Voltage-Based Alternative Repair Criteria

**A Report to the
Advisory Committee on Reactor Safeguards
by the
Ad Hoc Subcommittee on a
Differing Professional Opinion**

Date Completed: February 2001

Figure 3. Schematic Diagram of Natural Circulation in the Primary Reactor Coolant System. On the left, full loop natural circulation is shown. On the right, countercurrent natural circulation through the steam generator is shown.

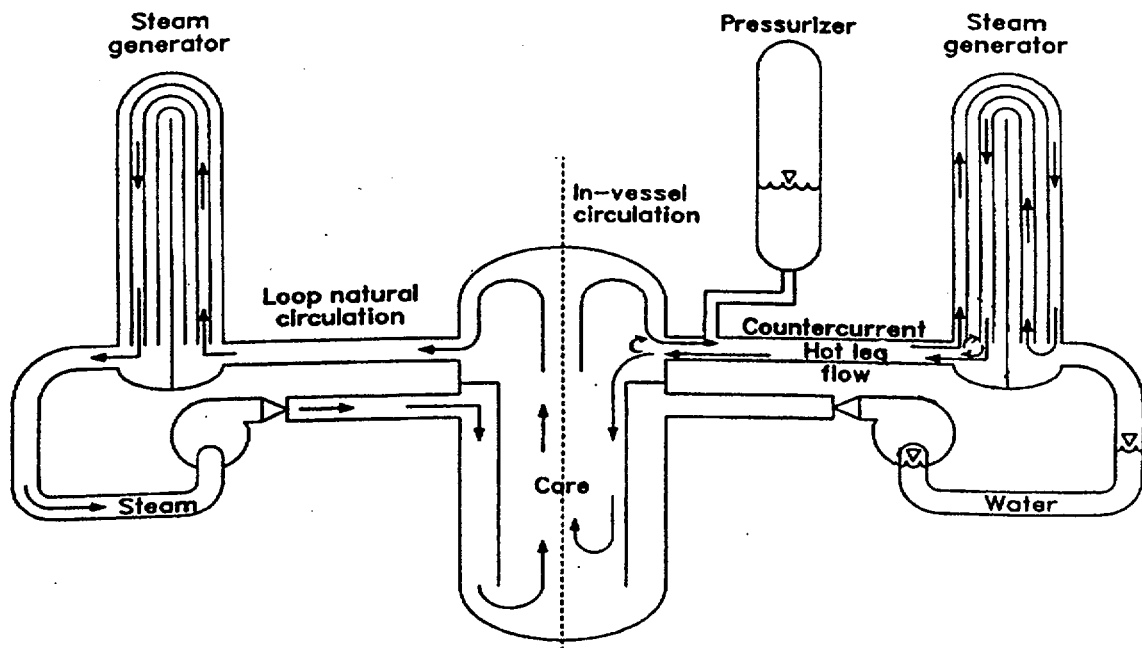
The staff has analyzed the possible evolution of severe accidents and the loads that they place on the steam generator tubes using computer models like SCDAP-RELAP5. These analyses [5] are predicated on the assumption that the "loop-seals" in the primary reactor coolant system remain in place, so there is not a gross convection through the reactor coolant system³. Instead, a countercurrent natural circulation of steam from the degrading reactor core through the steam generator tubes and back to the core is established. A schematic diagram of this natural circulation flow is shown in Figure 3. The analyses done by the staff indicate that heat is transferred to other parts of the primary reactor coolant system by the natural circulation flow, and failure at other locations is likely to occur before a steam generator tube undergoes gross failure as a result of creep rupture. Typically, the surge line is predicted to fail first, followed by failure of a reactor nozzle. The analyses also show that the timing of the failures at the various locations are not greatly different.

³ If a loop seal is opened and the coolant level in the pressure vessel is sufficiently low, an overall natural circulation of high-temperature steam through the steam generator and back into the vessel develops (see the left side of Figure 3.) This overall natural circulation is thought to impose sufficiently high heat loads on the steam generator tubes that the tubes fail whether they are flawed or not. Detailed analyses have not been done, but it is known that additional complexities can develop in the analyses of such scenarios, including episodic re-establishment of the loop seals.

The Ad Hoc Subcommittee concluded that the issue of the possible evolution of severe accidents to involve gross failure of steam generator tubes and bypass of the containment is not yet resolved. The Subcommittee also believes that the issue needs consideration regardless of the criteria adopted for the repair and replacement of steam generator tubes. The issue may be affected by any enhanced leakage that comes from the use of the alternative repair criteria described in GL 95-05. But, the issue is just one of several significant uncertainties that now exist in the assessment of severe accident progression.

Figure 4. Process Used to Estimate Leakage Rate

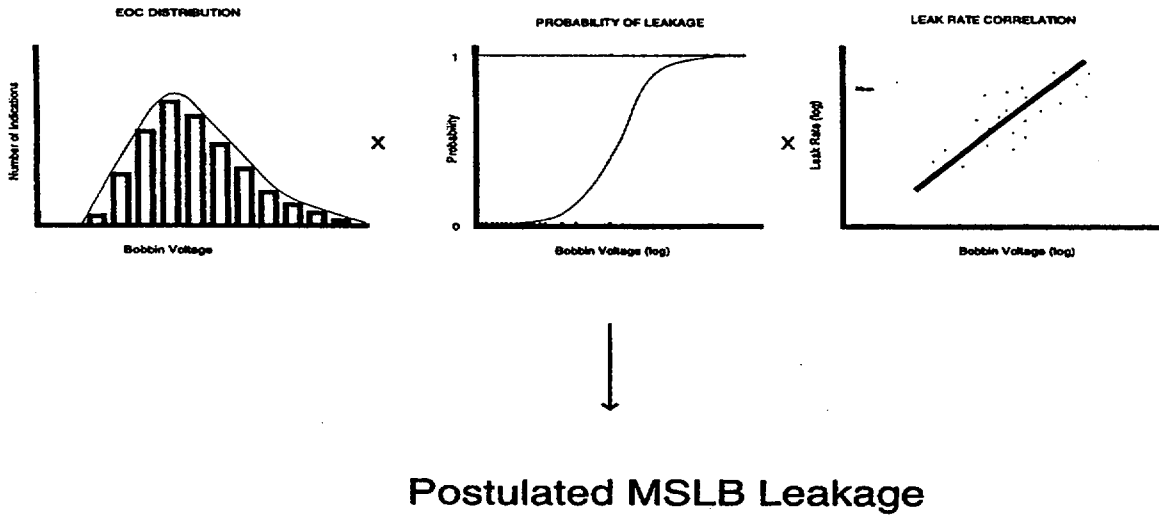
The prediction of the leak rate from tubes in a steam generator during a MSLB accident involves steps shown schematically in Figure 4. The process begins with a determination of a distribution of the number of flaws found during inspection of the steam generator as a function of the magnitude of the voltage signal produced by these flaws. The number of flaws in each voltage interval is increased by a factor equal to the reciprocal of the probability of detection (1/POD) of a flaw capable of producing a signal of this magnitude. The resulting distribution is multiplied by the probability that flaws producing signals of a given magnitude will leak. The resulting distribution is then multiplied by the leak rate in each voltage range found from a correlation of the leak rate with signal magnitude. Summation over the various voltage intervals yields a prediction of the leak rate during a MSLB accident.

The staff appears to be relying on a compensation of errors in the process to produce a result that is, overall, conservative. Based on the examples shown to the Subcommittee, the staff-approved procedure is yielding conservative results. The Subcommittee did find that the staff-approved procedure does not readily admit likely improvements in the technologies used to inspect steam generator tubes. A procedure more amenable to change with improving technology would consider the probability of flaw detection to be a function of the magnitude of the signal the flaw could produce and would adjust the number distribution to account for the probability of flaws being present that are capable of producing voltage signals in ranges where none had been found.

Figure 5. Process Used to Estimate the Tube Burst Probability

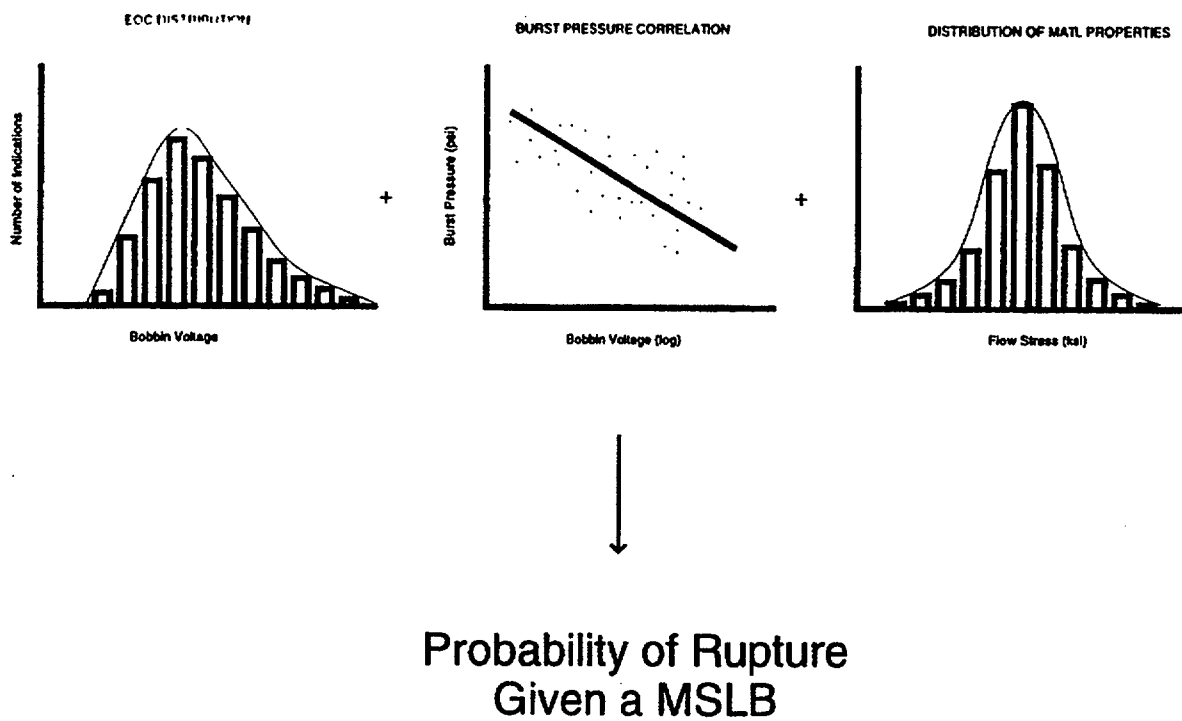
A schematic diagram of the process used for estimating the probability of tube burst is shown in Figure 5. The end of cycle distribution of flaws corrected for the probability of detection and the growth of flaws over the cycle is used just as in the estimation of leakage. This distribution is convoluted with the correlation of normalized burst pressure with voltage. The normalization factor is the flow stress, which is the average of the yield stress and the ultimate stress. The flow stress has a distribution due to the variability of material properties, so the analysis is done using Monte Carlo methods. The Ad Hoc Subcommittee did not examine the distribution of the flow stress. It did examine the correlations of burst pressure with voltage.

The Ad Hoc Subcommittee also examined the database in terms of the sources of the data. Data obtained from tubes flawed in model boiler tests constitute much of the data available for higher voltage signals. These data mesh smoothly with the lower voltage data obtained from tubes removed from service. That is, there was no readily apparent indication that the two data sources yielded results that were indicative of radically different population distributions for flaws.

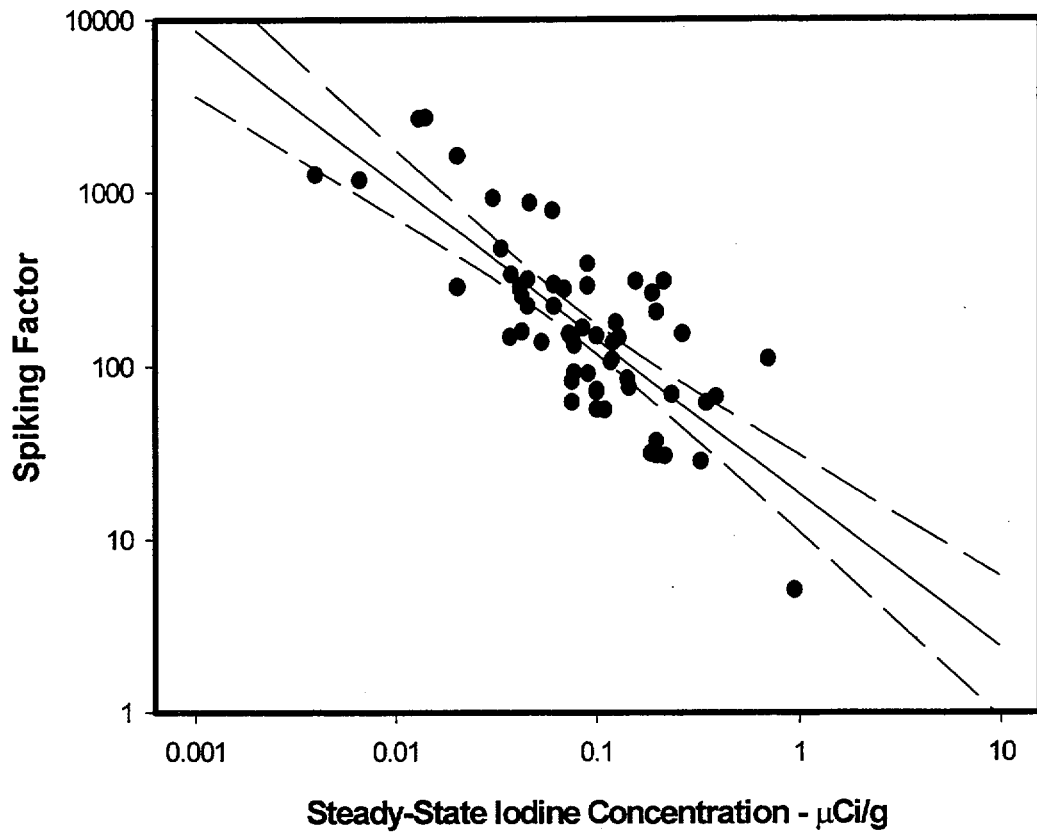
The DPO author contends that the spiking factor used for the accident analyses is too low when the Technical Specification limit on the iodine concentration in the coolant during normal operations has been reduced. He argues that the spiking factor increases with decreasing steady-state iodine concentration. Data collected and reviewed by Atwood and Sattison [17] substantiate the claim made by the DPO author (See Figure 6). A phenomenological understanding of this correlation

where $N = 58$ is the number of data points used to construct the correlation. These bounds are indicated in Figure 6 by the dashed lines on either side of the solid line calculated from the correlation.

The DPO author rightly contends that the iodine spiking factor seems to exhibit a correlation with the initial iodine concentration in the coolant. But, it might be argued that for accident analyses the appropriate spiking factor to use is that found from the empirical correlation using the actual operational iodine concentration rather than the Technical Specifications limit adopted by the licensee, whether it is 1.0 $\mu\text{Ci/g}$ or 0.01 $\mu\text{Ci/g}$. Such a procedure would be inconsistent with the approaches that have long been used in the analysis of design basis accidents. The Ad Hoc Subcommittee also believes that the empirical, linear correlation of spiking factor with initial iodine concentration to the very low initial iodine concentrations typical of many plants today without explicitly accounting for data uncertainties and variations in the mechanisms that lead to operational levels of iodine in the coolant is without sound technical foundation.

Data are available to develop a correlation of the spiking factor with steady-state iodine concentration for analysis of steam generator tube rupture events. If this is done, the correlation should be used with whatever Technical Specification limit on the iodine concentration has been adopted by a licensee rather than the operating iodine concentration typical of the plant. This will maintain consistency with past practices in the analyses. If the staff continues to believe that the spiking factor is greater in a main steamline break because of high differential pressures, another specification of the spiking factor needs to be developed. The Ad Hoc Subcommittee believes, however, that it would be better for the staff to develop a more realistic mechanistic understanding

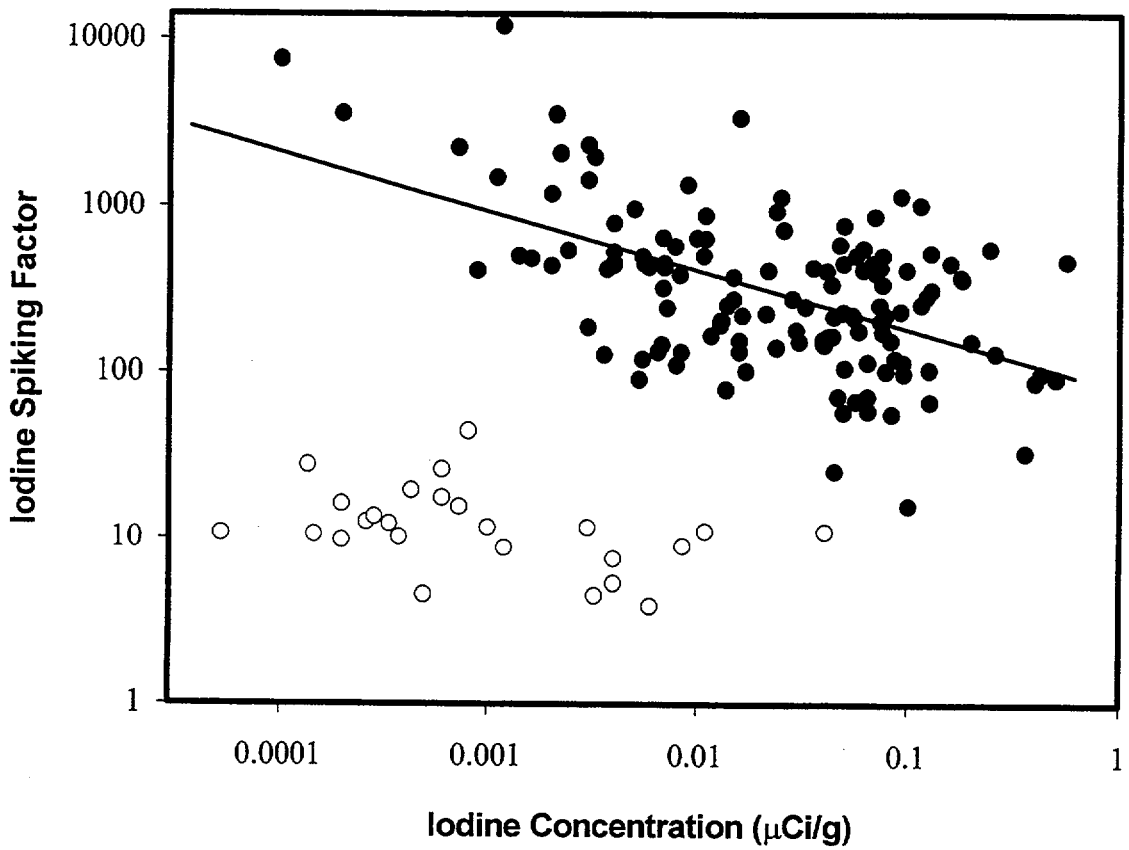
The staff provided the Ad Hoc Subcommittee with an expanded data set on spiking factors. The pedigree of this database is uncertain, but it definitely is not the database used to prepare plots of spiking factor as a function of the initial, steady-state iodine concentration of the coolant shown to the Subcommittee and included in the staff's responses to the DPO. This database seems to be composed of two populations (See figure 7). In one population, the spiking factor does exhibit a dependence on the initial, steady-state iodine concentration. Spiking factors from the other
